Value Engineering Study Report – Final

I-69 Ohio River Crossing Project Evansville, IN and Henderson, KY

August 2, 2019

Idea Title	Relocate Parcel 627 access
Function	Access Community

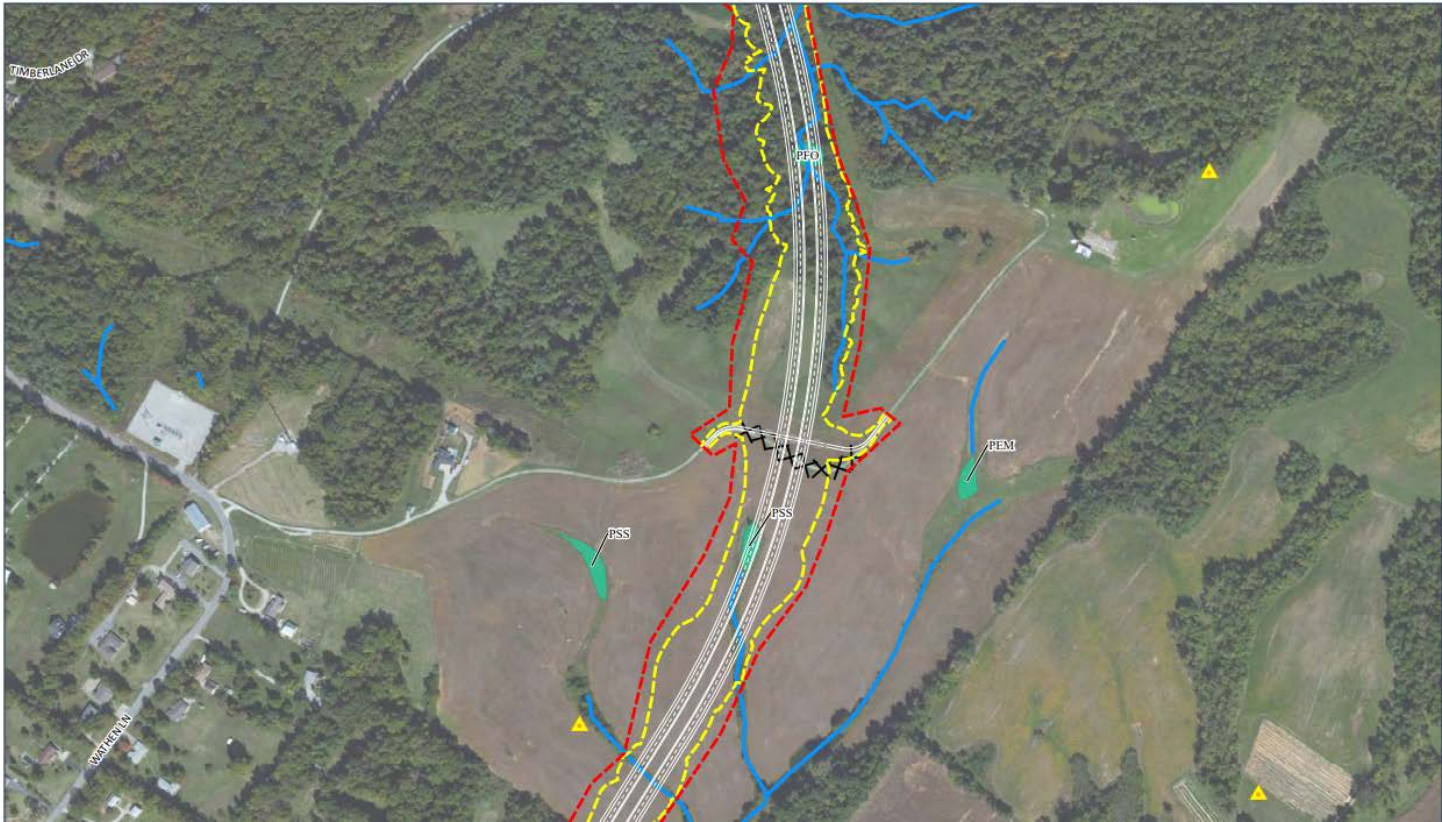
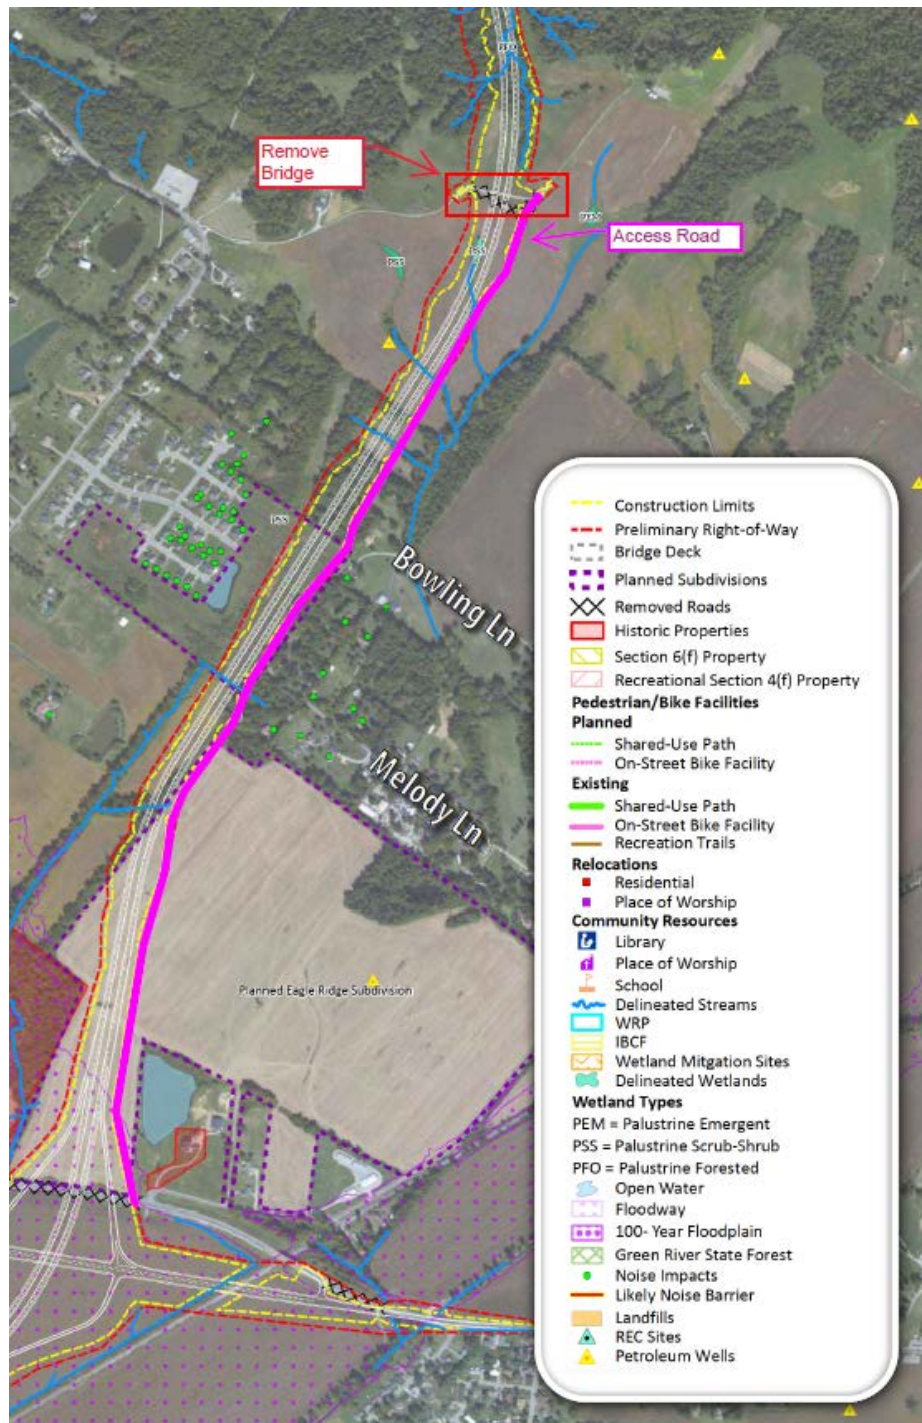
Rough order of magnitude impact to schedule (add/reduce schedule) – 3 months
Eliminating the bridge and being able to construct the gravel road at the same time as the I-69 corridor

\$1,660,000 - \$600,000 = \$1,060,000

Idea Title	Simplify/minimize I-69 interchange at Veterans Memorial Parkway
Function	Access Community

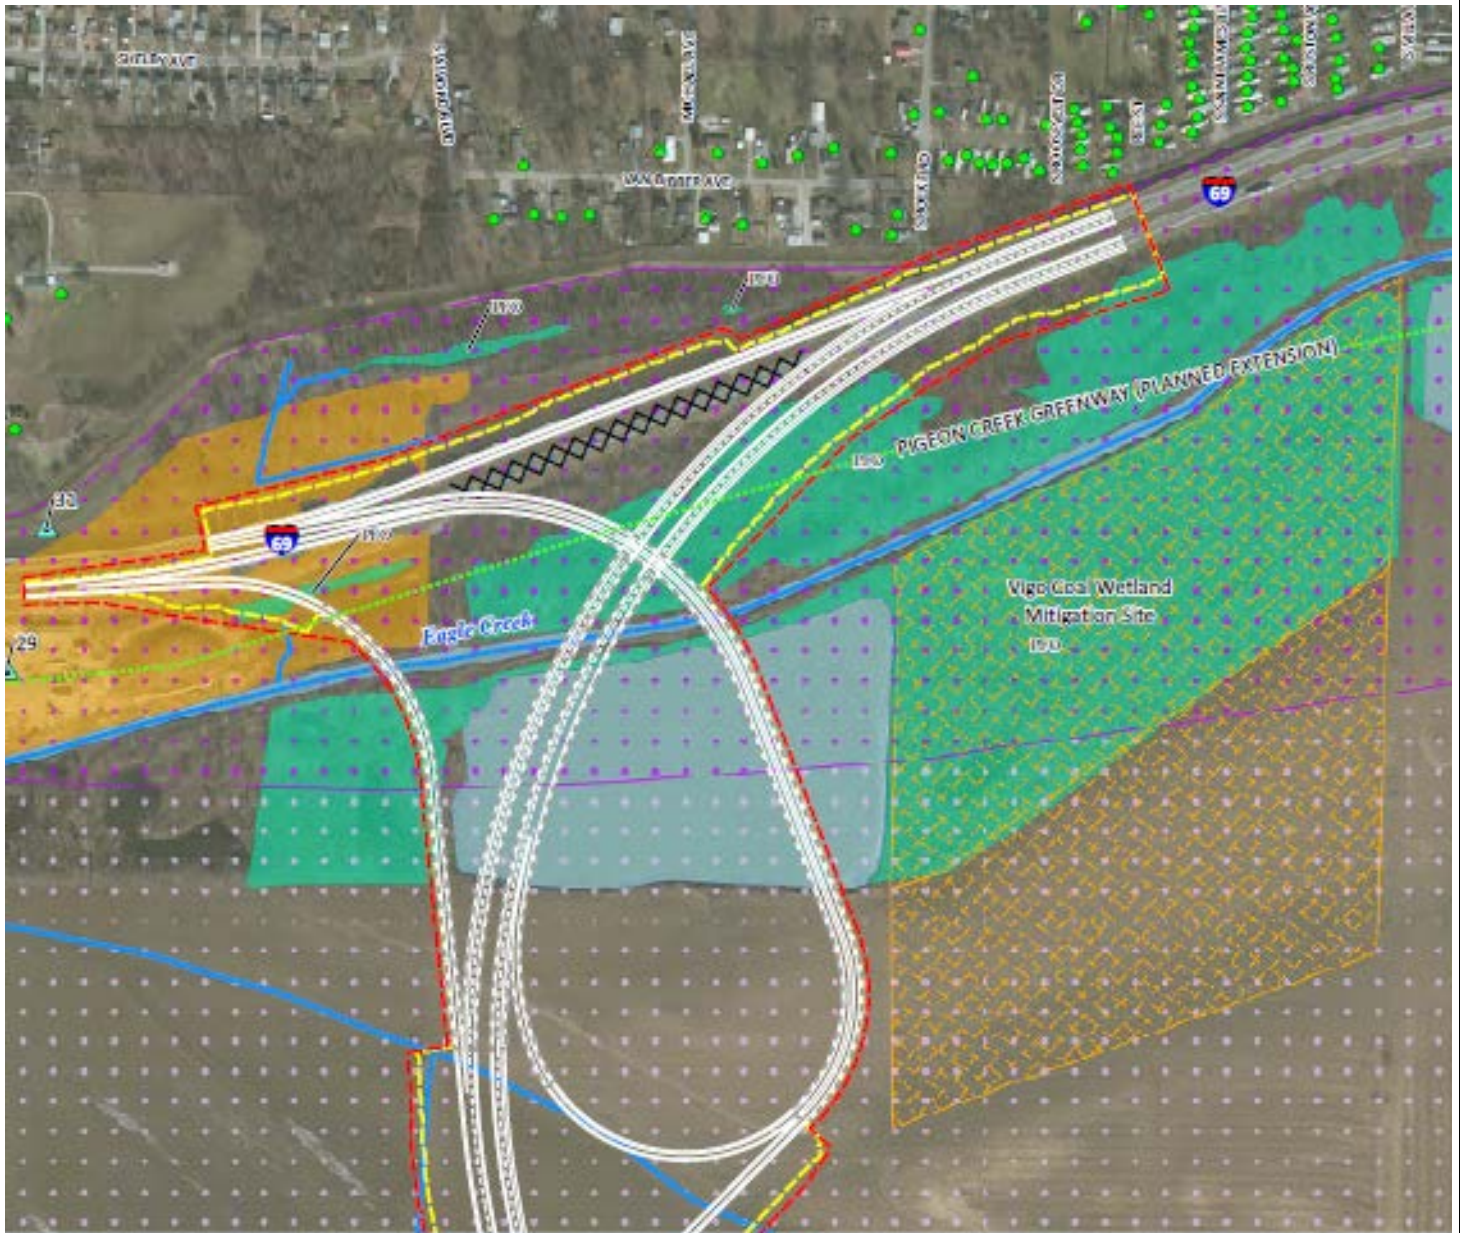
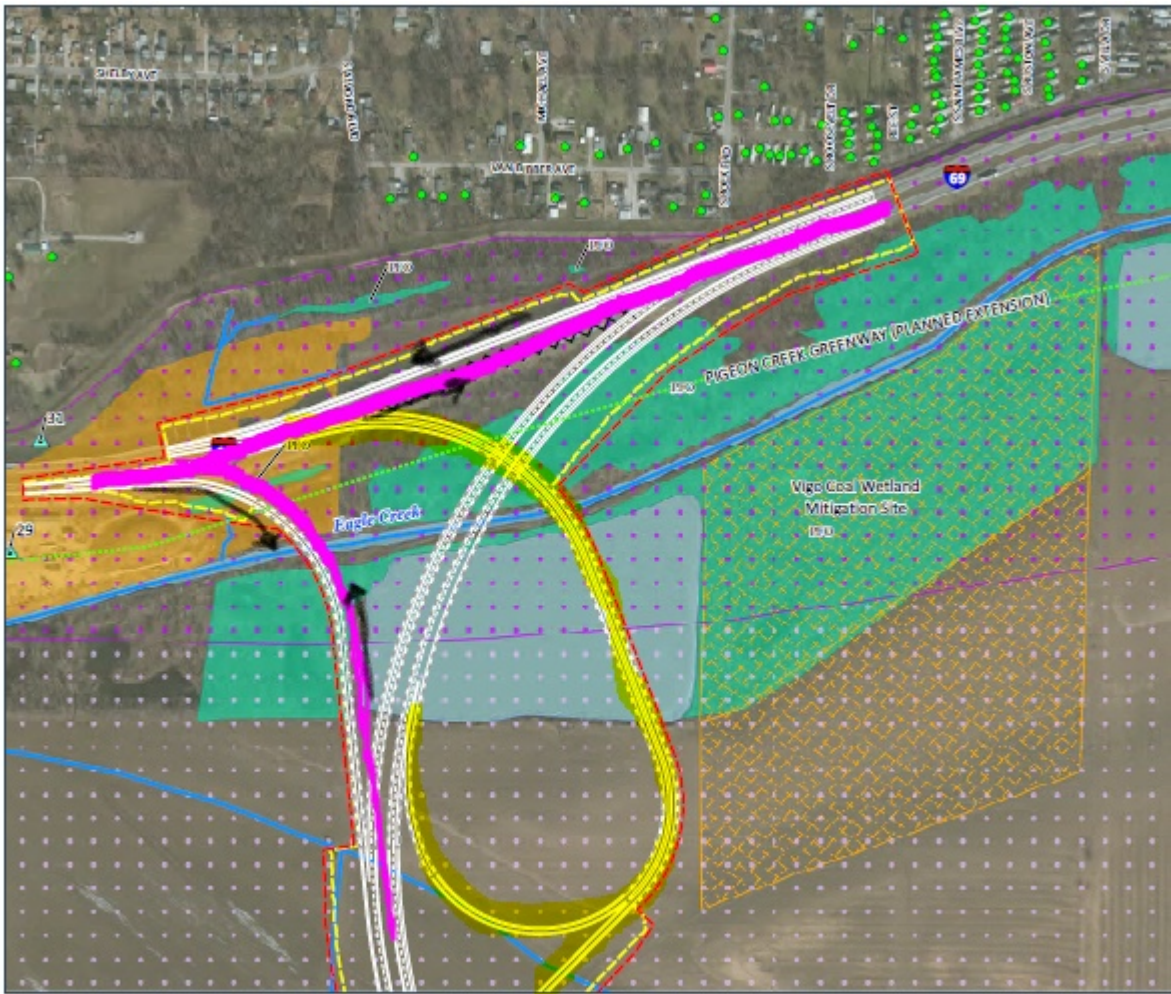
1. No change to eastbound VMP to southbound I-69 ramp movement.
2. Construct northbound I-69 at a higher elevation (17 feet) than southbound I-69. This allows a northbound I-69 left off ramp (fast lane exit) to crossover southbound I-69 to tie-in with westbound VMP. Additionally, this same northbound I-69 to westbound VMP will have a left side on-ramp to westbound VMP. This left-off to left-on ramp proposal shortens the bridge length requirement and allows for a great portion of the ramp constructed on fill.

4. No change to southbound I-69 to westbound VMP ramp.

May reduce environmental permit requirements by smaller footprint construction in floodplain.

Eliminate

Proposed change

VALUE ENGINEERING PROPOSAL NO. AC-07

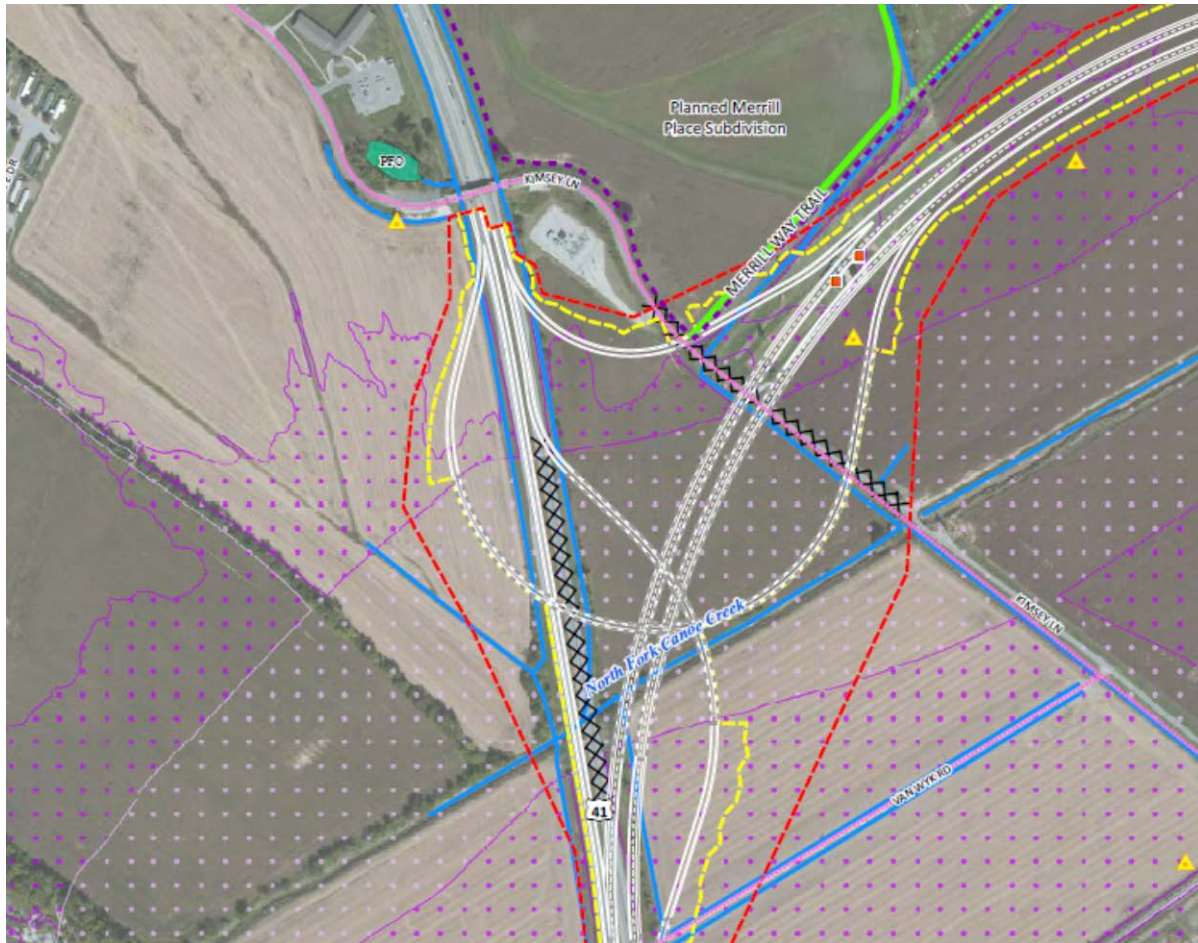
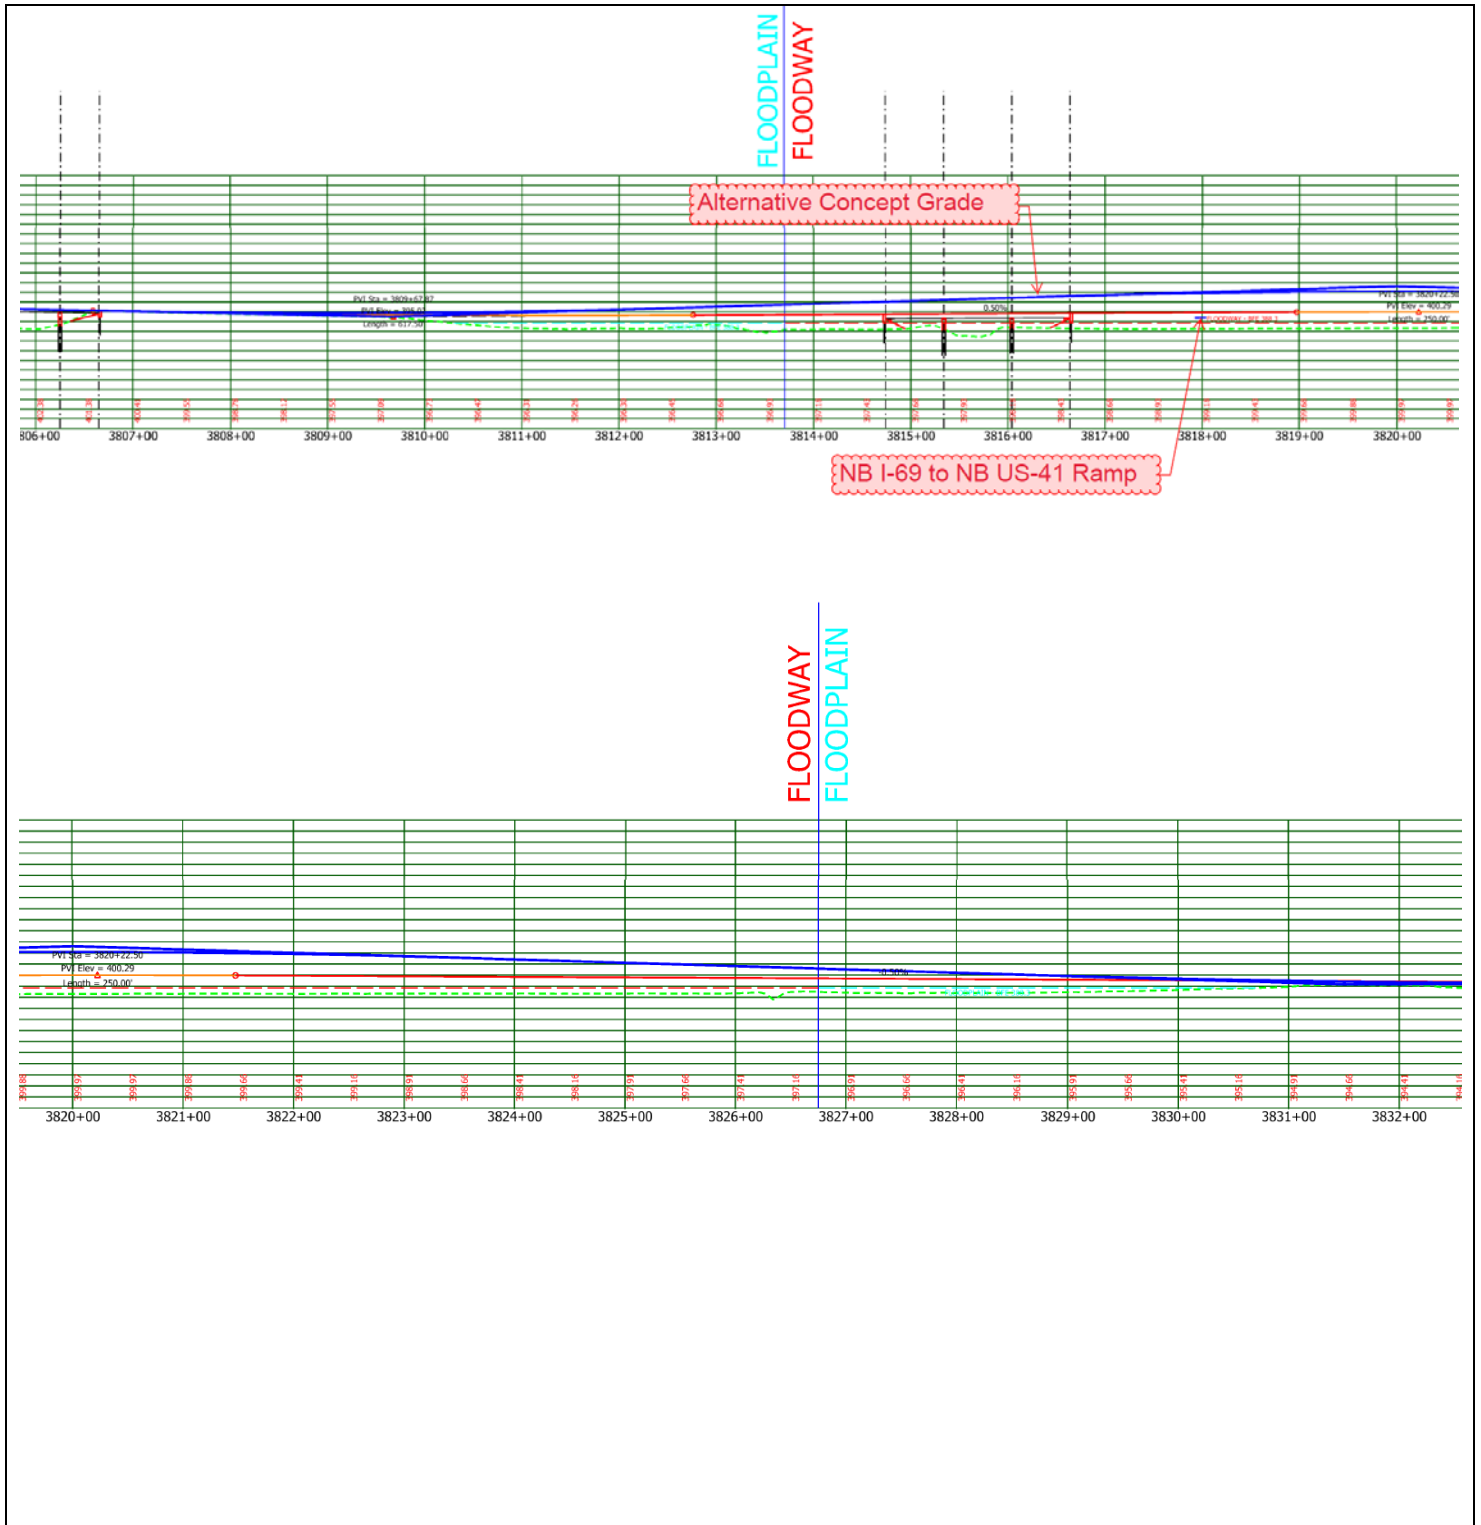
Additionally, a signalized single crossover and a Single-Point Urban Interchange (SPUI) alternative were briefly reviewed for this location, but the project team's expressed desire to maintain an unimpeded movement for through traffic on US 41 halted further exploration. The single crossover required implementation of a multi-level interchange, where the cost savings would have been negligible.

Figure 1: Estimated Tributary area of Canoe Creek

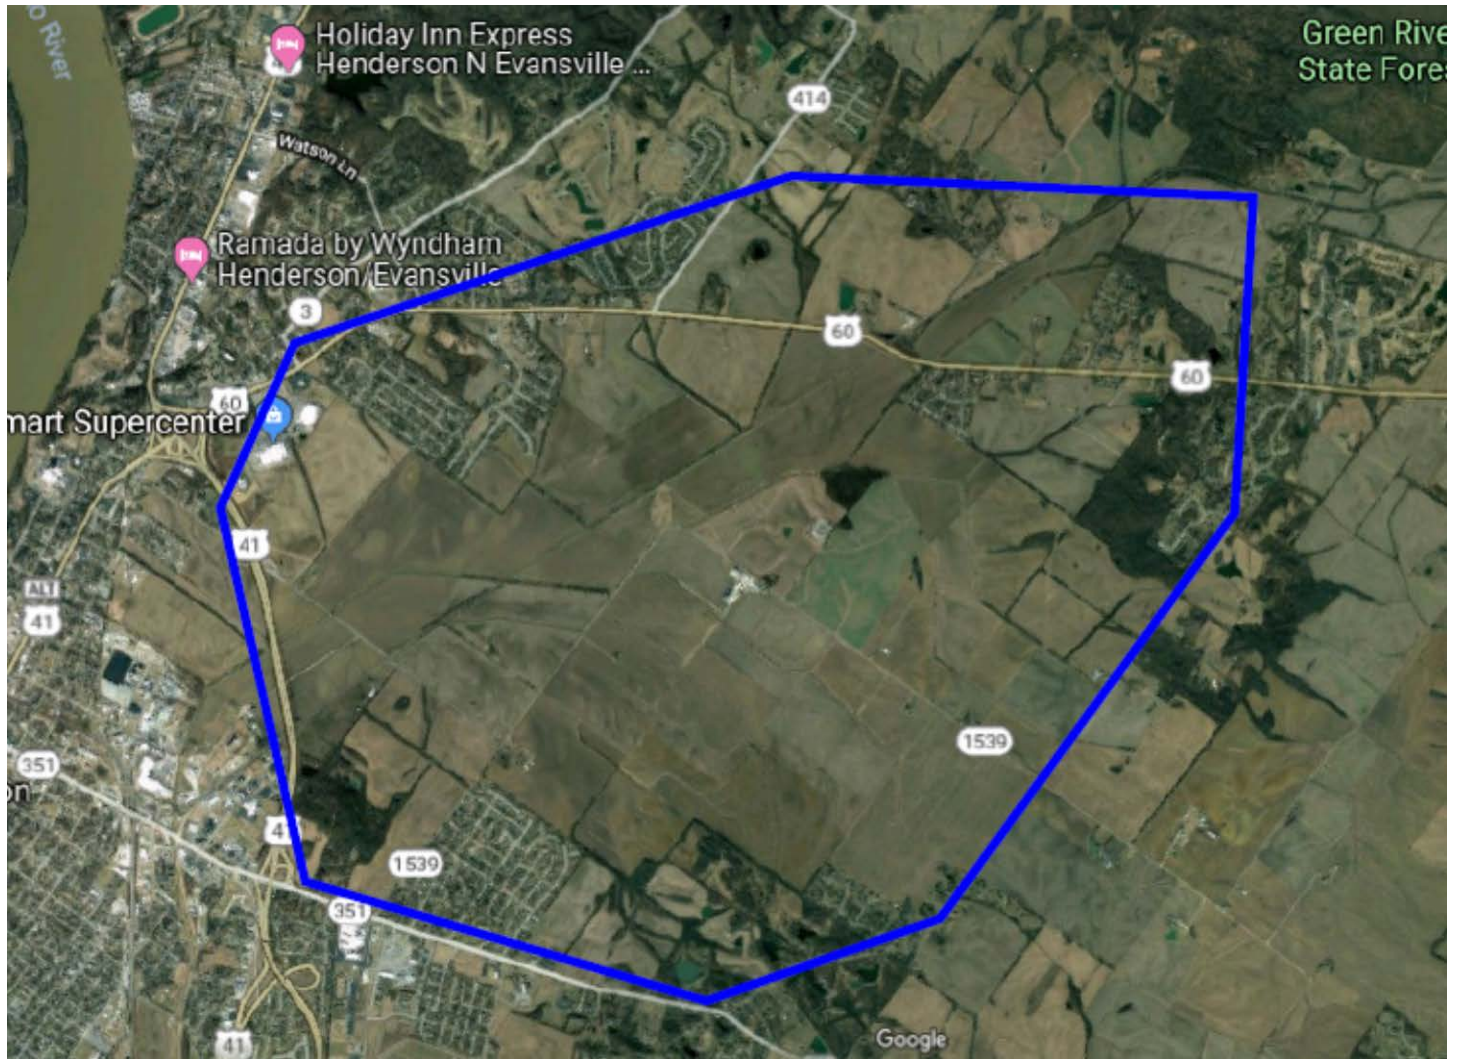
The hydraulics around proposed I-69 / Canoe Creek area offers unique opportunity to reduce the bridge structure within the floodway areas. In Figure 2, this proposal reduces the hydraulic opening to about 250 feet. There are three factors supporting replacing bridge structure with embankment or roadway within the floodway area:

2. Based on a rough measure from Google Map, the Canoe Creek covers a tributary area of about 20 square miles (see Figure 1). Therefore, the amount of water expected to flow out of Canoe Creek at the US 41 interchange is small. The floodway area here behaves more as storage, not waterway. Additional storage capacity can be easily provided to compensate the area occupied by proposed roadway within the floodplain.

3. The Kentucky one-foot back water requirement provides a relatively large allowance in terms of hydraulic impact. Considering the rather small tributary area and the flat and large flood storage area, it will be very unlikely the proposed change will result in high back water.

The estimate provided does not reflect the current bridge layout. Measured from the current bridge layout, the bridge areas of the four structures are: I-69 northbound on ramp 65,025 sf, I-69 NB off ramp: 29,360 sf, I-69 NB: 59,700 sf, I-69 SB 61,200 sf, for a total of 215,285 sf. Figure 2 shows the proposed bridge layout, using a hydraulic opening of 250 feet. The proposed bridge areas are approximately: I-69 north bound on ramp 43,500 sf, I-69 north bound off ramp: 17,600 sf, I-69 north bound: 15,000 sf, I-69 south bound 15,000 sf, for a total of 91,100 sf. The average bridge cost from the estimate is about \$300 per square foot. There would be an estimated saving of \$190 per square foot from bridge to embankment. The total saving of this proposal is estimated at \$23.6M.
